Addressing comment #71

Adee Ran, Cisco

Figure 171–2—Functional block diagram for the PHY 800GXS

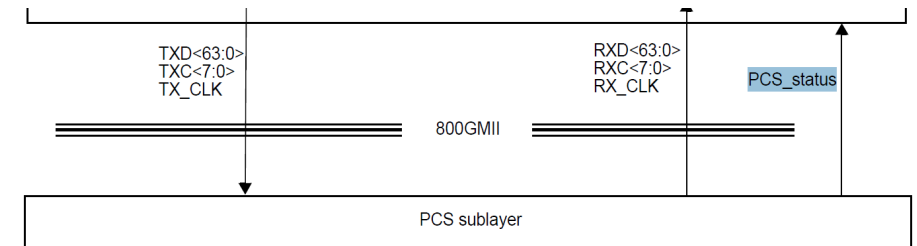
- PHY_XS:IS_SIGNAL.indication was added in 171.3.2
- PCS_Status added to service interface below in 171.3.3
 - An additional signal, PCS_status, is provided in the receive direction (see 172.1.4.1)
- Added Link fault signaling subclause

The PHY 800GXS provides signal status information to the PMA using the PHY_XS:IS_SIGNAL.indication(SIGNAL_OK) primitive (see Figure 171–2). The SIGNAL_OK parameter is set to OK when PCS_status (see 171.3.3) is true and FAIL when PCS_status is false.

The PHY 800GXS provides signal status from the local PHY to the client PMA using the PHY_XS:IS_SIGNAL.indication(SIGNAL_OK) primitive (see 171.3.2 and Figure 171–2).

Proposed change: Apply corresponding changes for PHY 400GXS in Clause 118 with editorial license
No figures need to be updated

- Figure 172–2 updated

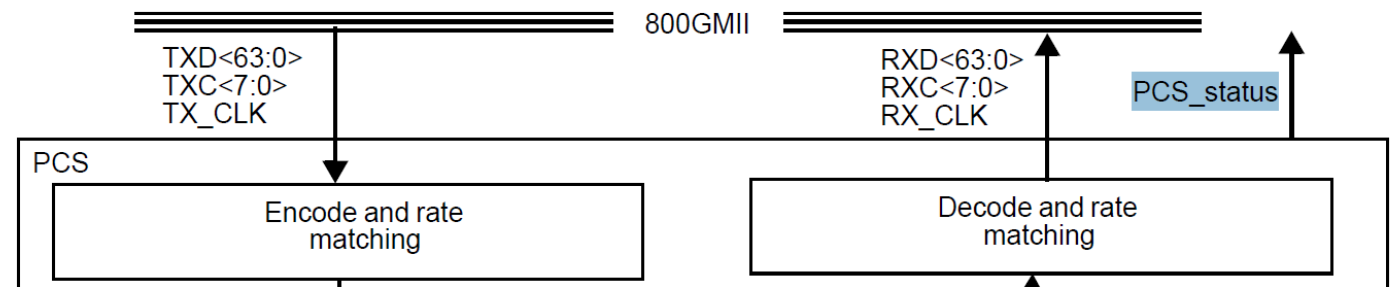
- PCS_Status was added to the service interface

When the client is the PHY 800GXS sublayer, the PCS Service Interface is the 800GMII in Clause 170 with an additional signal, PCS_status, in the receive direction. The PCS_status signal indicates the state of the PCS_status variable (see 119.2.6.2.2).

Proposed change: Apply corresponding changes for the 400GBASE-ZR PCS in Clause 155 with editorial license
Update Figure 155–3 adding PCS_Status output (aside from the 400GMII)

Figure 173-4—8:32 PMA functional block diagram

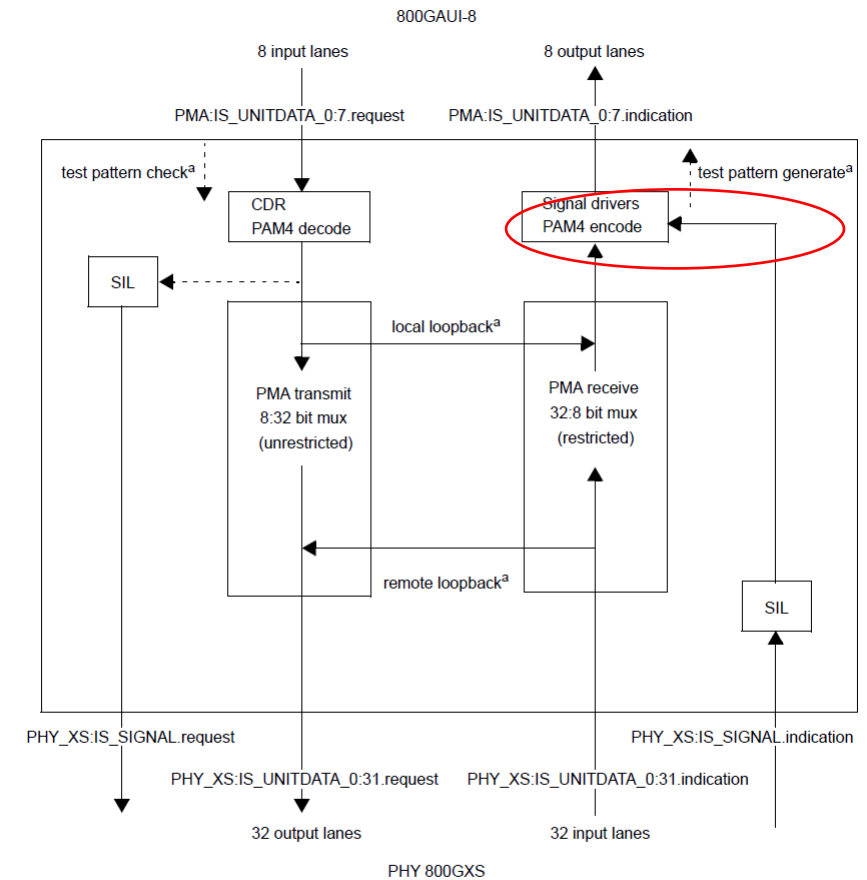
In the receive direction the 8:32 PMA optionally provides signal status information to the client PMA by disabling one or more output lanes (PMA:IS_UNITDATA_0:7.indication) when the PHY_XS:IS_SIGNAL.indication SIGNAL_OK parameter (see 173.3 and Figure 173–4) is FAIL.

- Change made to Figure 173-4 showing that the SIL can disable the output.
- Figure 120-5 is the corresponding diagram for the 400GBASE-R PMA.
 - It is a more complicated diagram.

Applying a similar change in Figure 120-5 would be nice to have but not absolutely required.
Editorial license provided.
